SERVICE BULLETIN

Subject: Change to MDT3, 4, 5 and 6 Controller

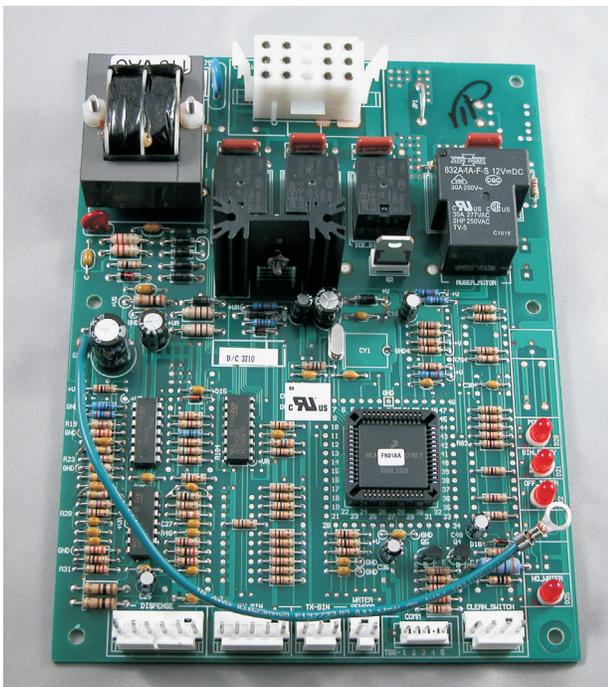
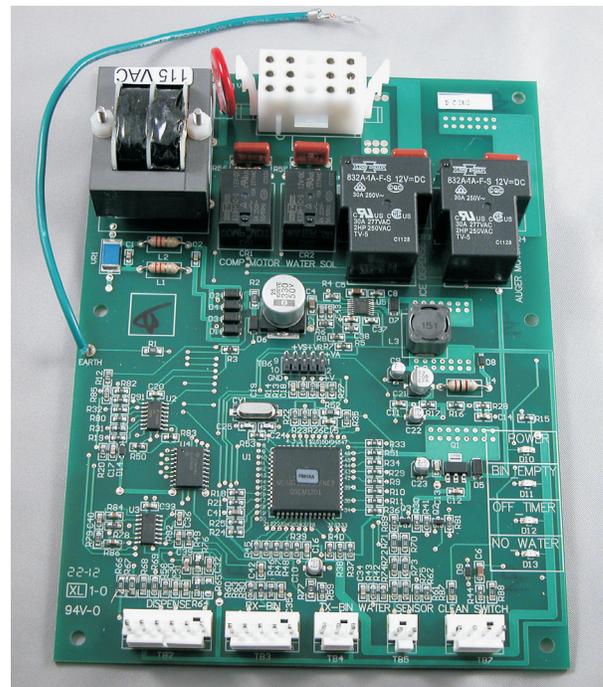
The controller used on the MDT3, MDT4, MDT5 and MDT6 has been changed.

The change began with MDT6N90A-1J, serial number 12101320011878, manufactured on 10-16-12.

The controller is now manufactured with surface mount technology, which makes the controller appear different. See the photos below. Also changed was the dispense relay. Its rating was increased to 30 amps to reduce possible contact damage. A damaged relay could increase the potential of continuous dispensing.

There are no operational differences between the two, all prior features are continued in the new controller and they are interchangeable.

The service controller, part number 12-2843-21, has also been changed.
